Washington Public Power Supply System
A JOINT OPERATING AGENCY

April 17, 1979
G02-79-70

Subject: WPPSS NUCLEAR PROJECT NO. 2
SUBMITTAL OF LEGIBLE COPIES
OF NRC QUESTIONS 312.16 AND 331.20

Q 312.16

CORROSION RATE
Mg Per Sq.Dm. Per Day

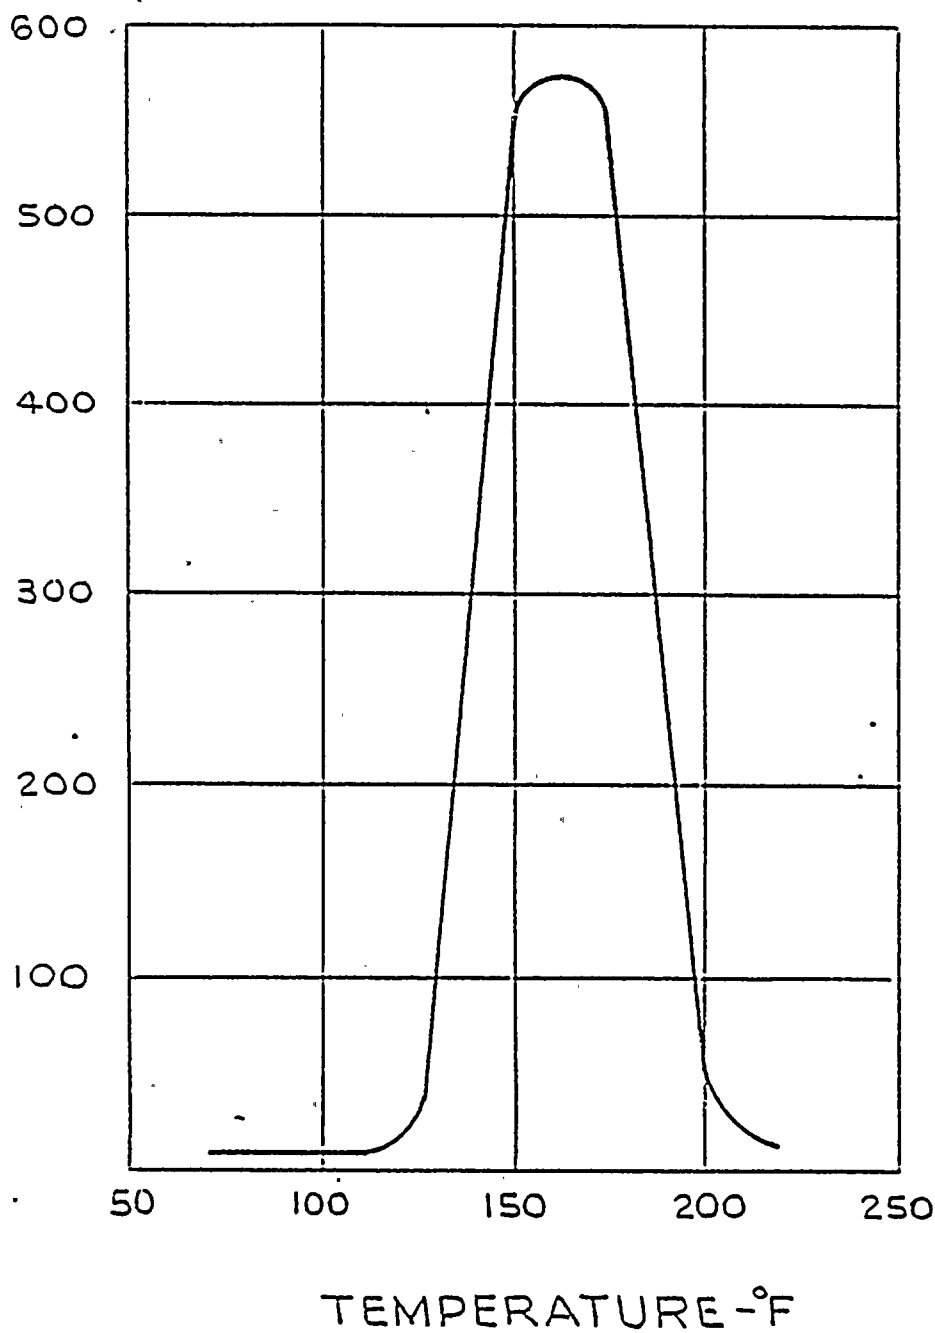
Work by Roetheli, Cox and Litteral has very effectively drawn the limits of the neutral, hydrate-forming zone in tests in distilled water with hydrochloric used to throw the solution acid and/ sodium hydroxide alkaline. The solutions were kept rather strongly agitated." Figure ~~7~~ depicts the results.

McKay and Worthington ⁶ explain that: "The hydrate is seen to have been most protective between the neutral point of $\text{pH} \approx 7$ and $\text{pH} \approx 2.5$. The fact is brought out that the exact shape and location of this curve is typical probably only of the particular set of conditions under which the tests were made. Factors such as agitation, aeration, salts in the solution, and temperature, in conjunction with hydrogen-ion concentration, affect the characteristics of film formation. The investigators conclude in a universal sense the condition of low or negligible corrosion probably lies between pH values of 6 and 8 as a minimum and 11 as a maximum."

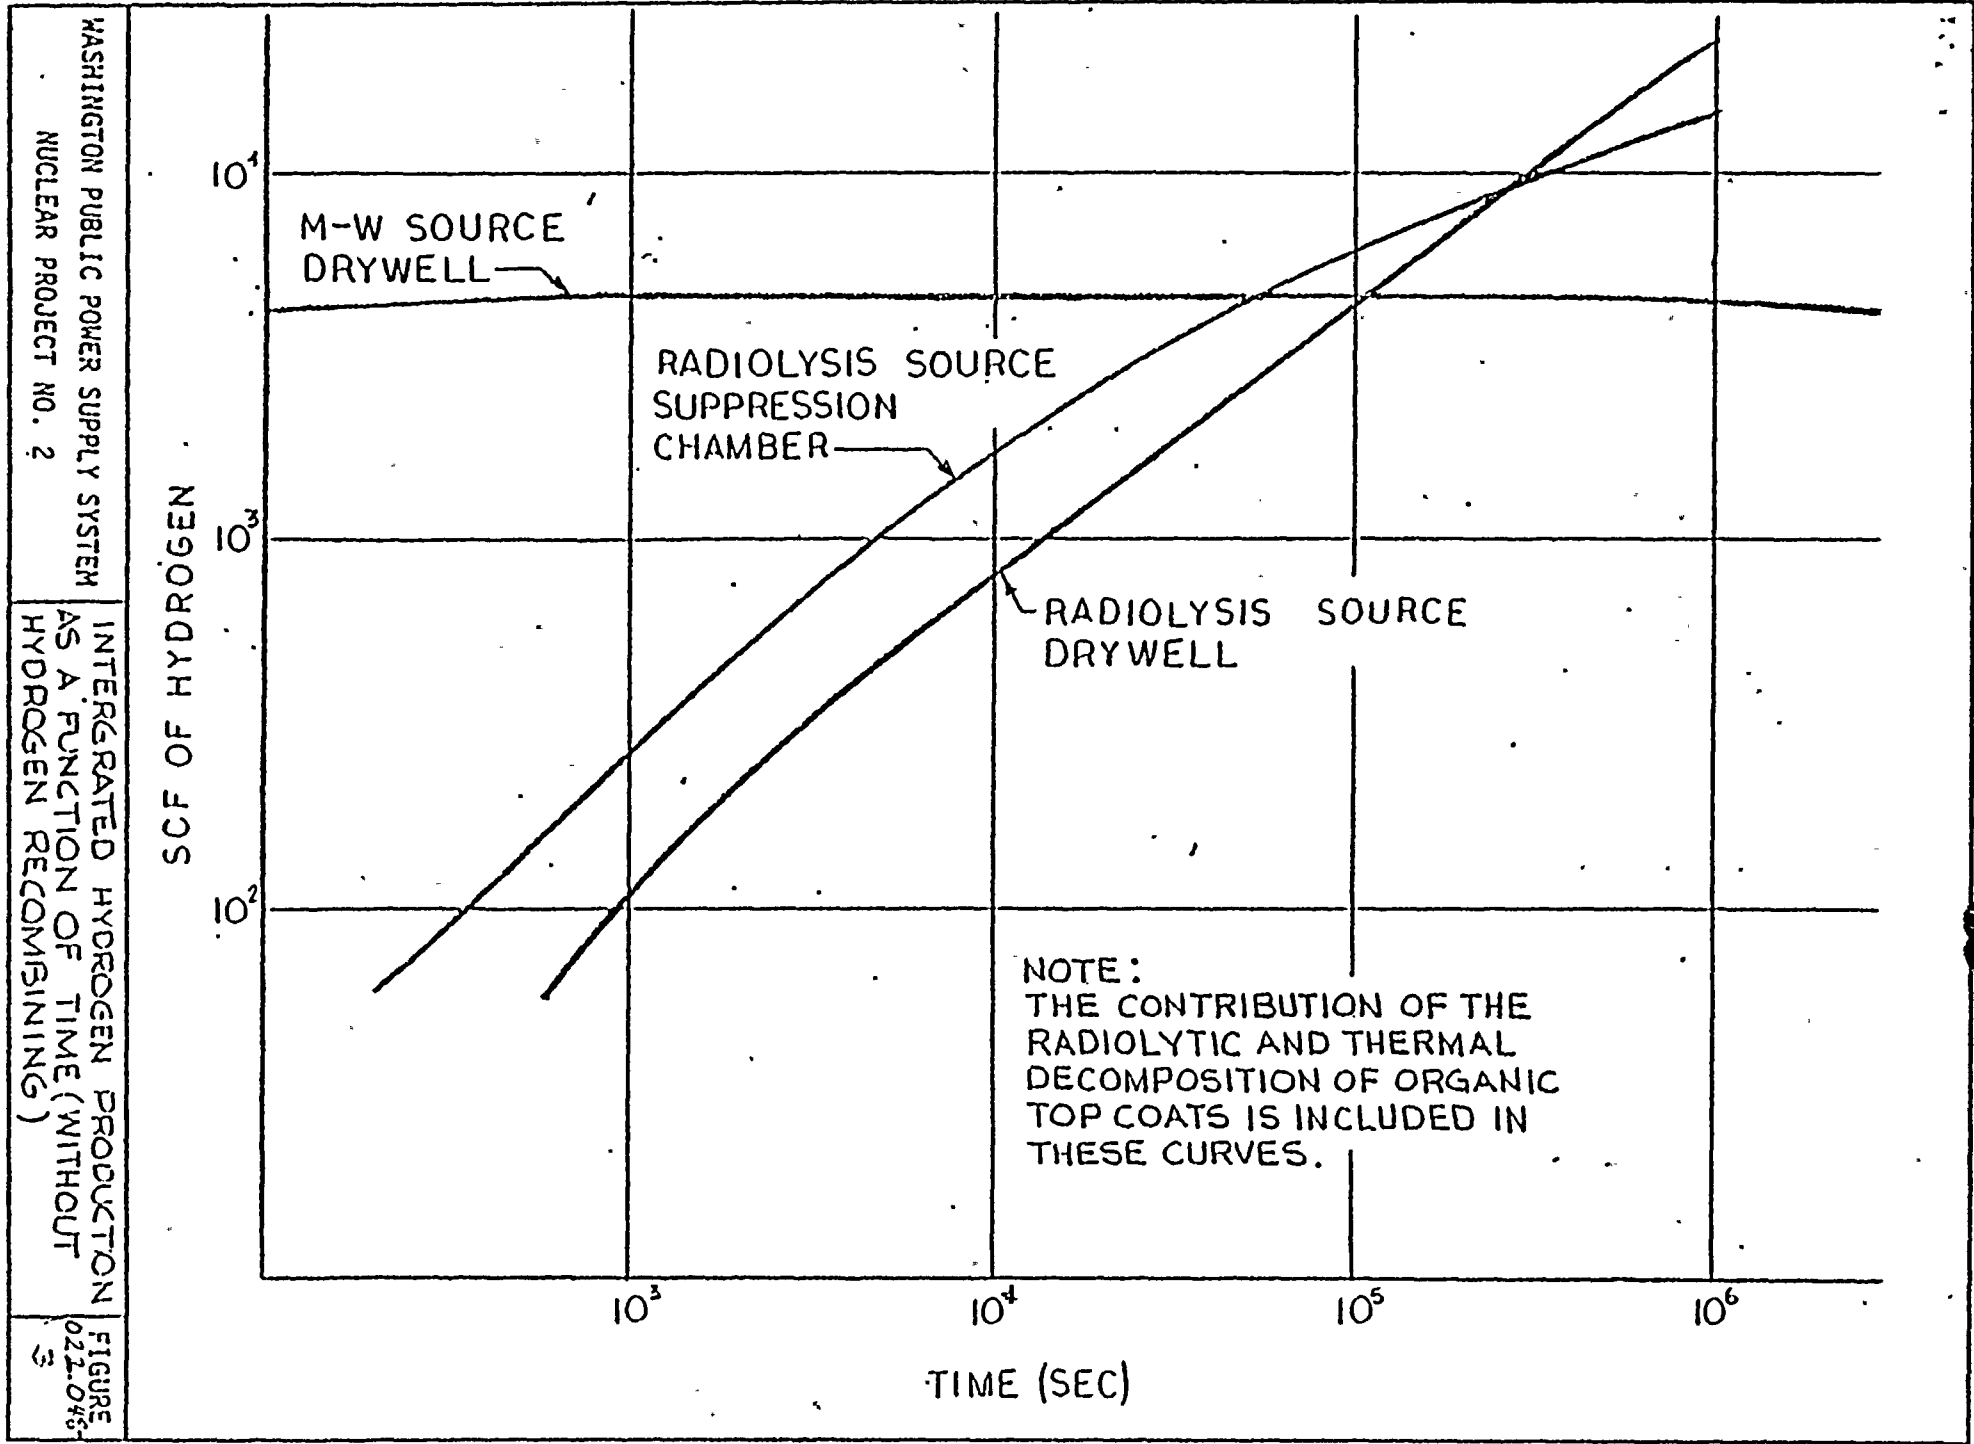
Cox ⁷ in a paper titled "Effect of Temperature on the Corrosion of Zinc", established the effect of temperature on the behavior of zinc in distilled water. The specimens were constantly in motion in the solution, and the solution was aerated with a stream of unwashed air bubbles. The duration of the test was 15 days.

The results of their investigation are shown in Figure 022.048-2.

Examination of the zinc hydrate film showed that the strong increase in corrosion coincided with a change in the nature of the film from an adherent gelateneous state to a non-adherent granular state.

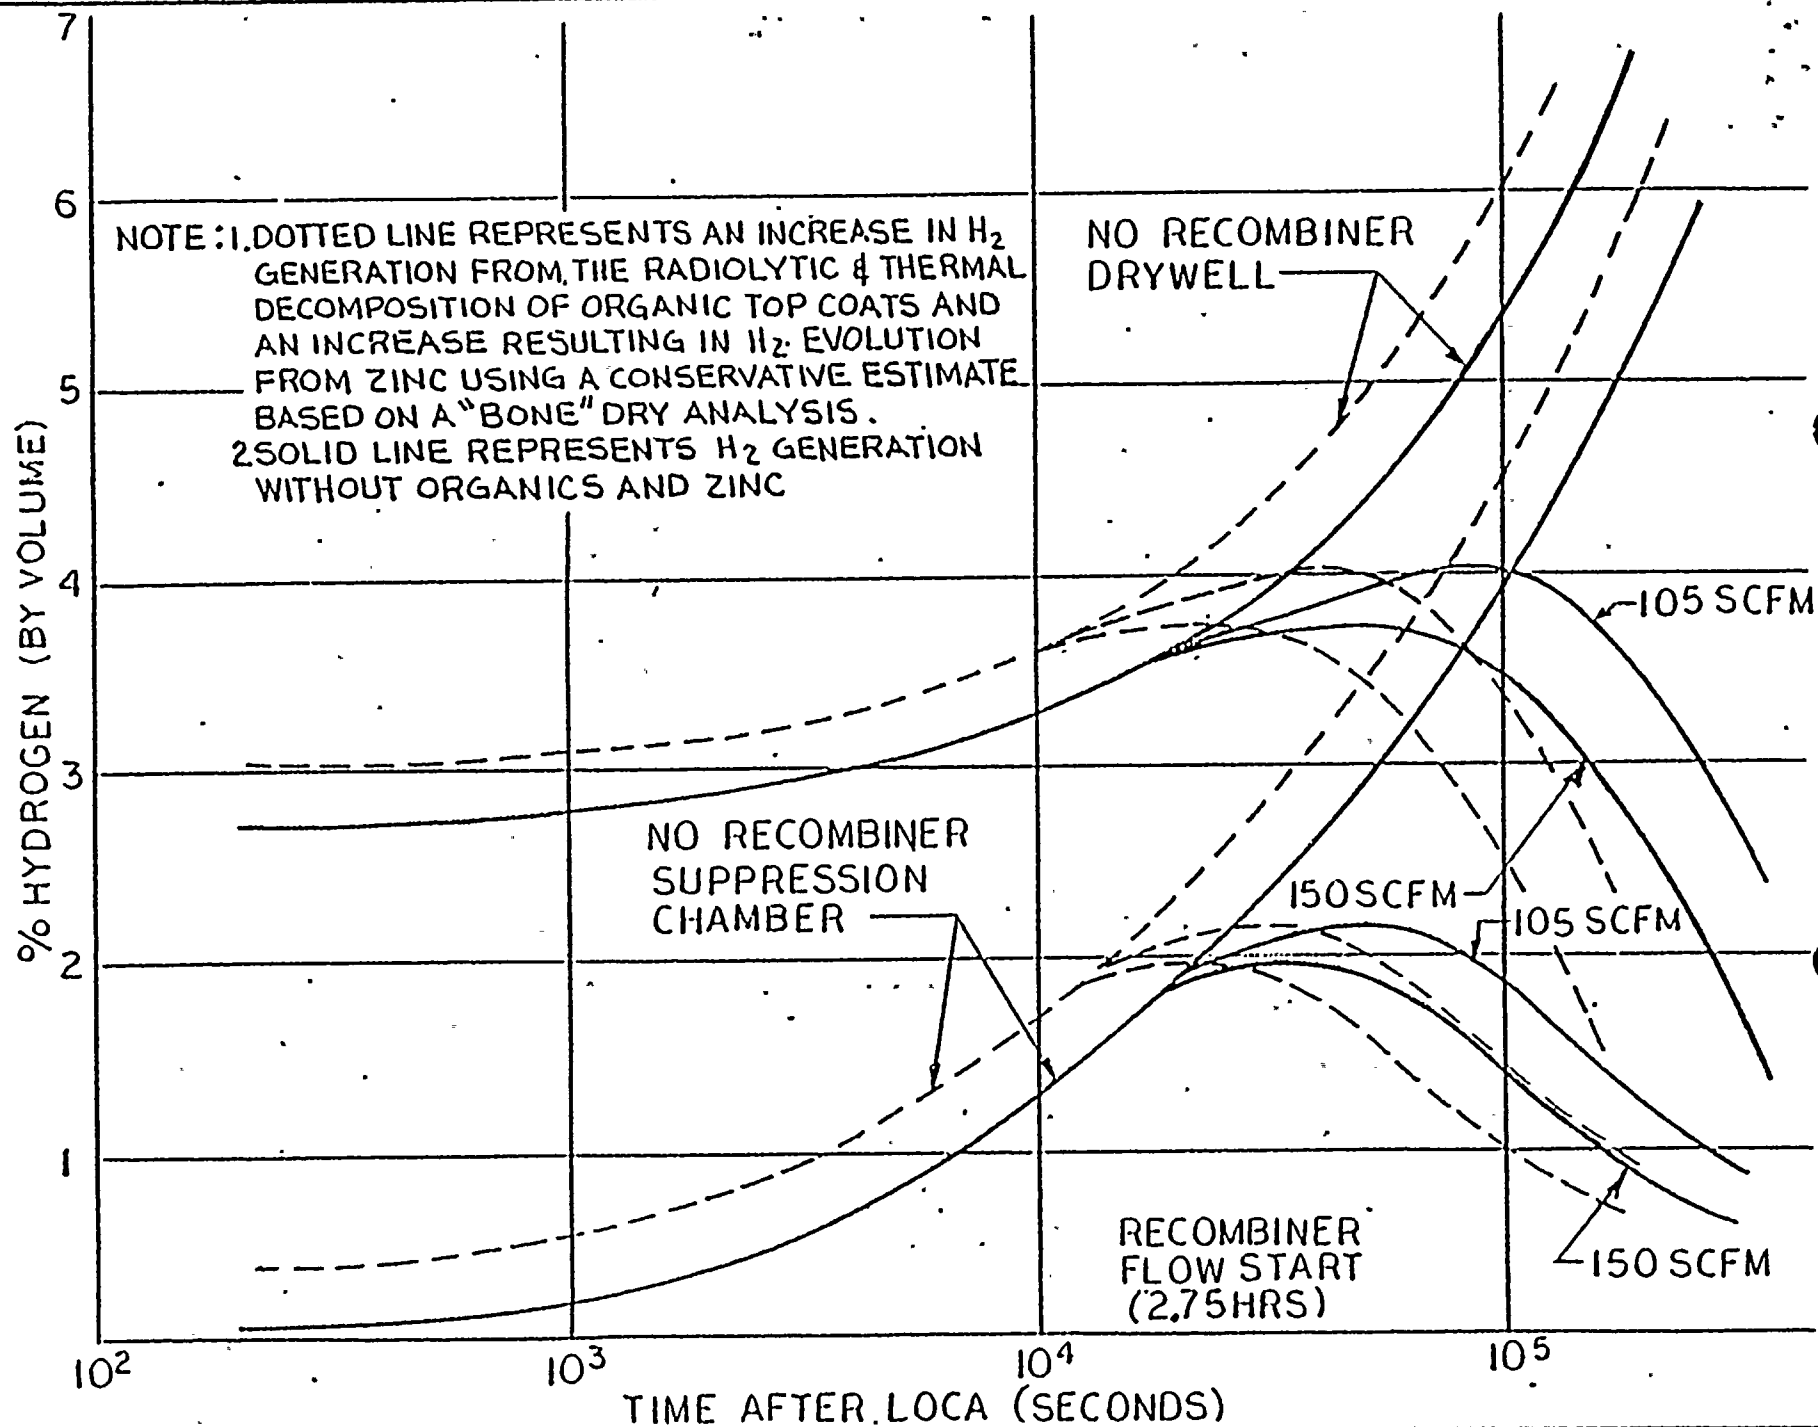
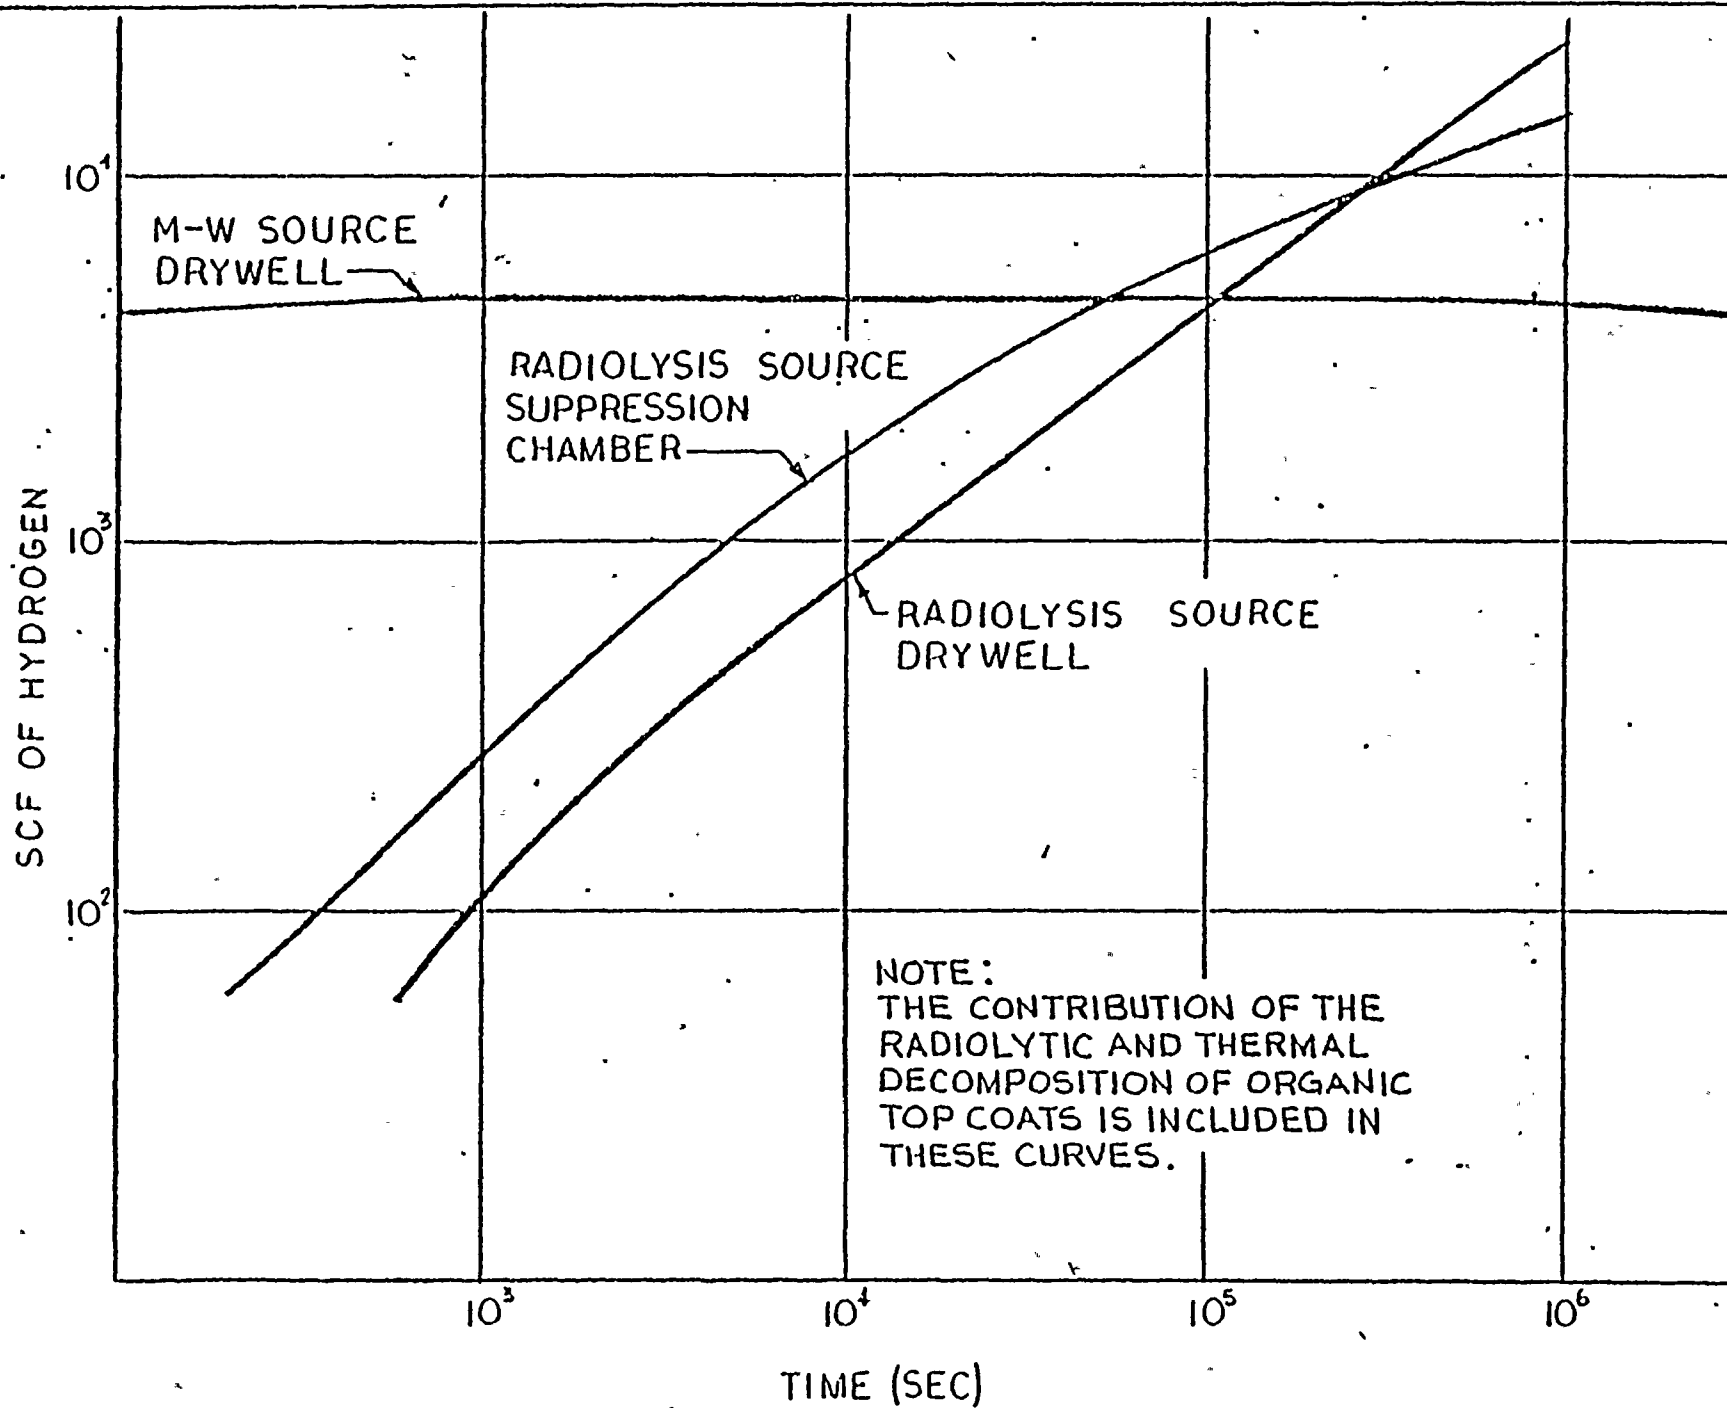
- c. Provide the mass and surface area of zinc paint and galvanized steel and other corrodible materials in both the drywell and the wetwell.
- d. Provide a graphic representation of the total hydrogen concentration inside the containment as a function of time with (1) no hydrogen recombiners operating; (2) one recombiner operating; and (3) both recombiners operating.

- e. Provide a graphic representation of the contribution of each source of hydrogen as a function of time.
- f. Describe the periodic surveillance that will be done to demonstrate the operability of the hydrogen recombiners and the backup purge system.

- d. The graphic representation of the total hydrogen concentration inside containment as a function of time is shown in Figure 4.

- e. The graphic representation of the contribution of each source of hydrogen as a function of time is shown in Figures 3 and 4. ^{as}

The evaluation is included in the response to NRC question 022.048. The results are taken into account in Figures 6.2-26 and 6.2-30.
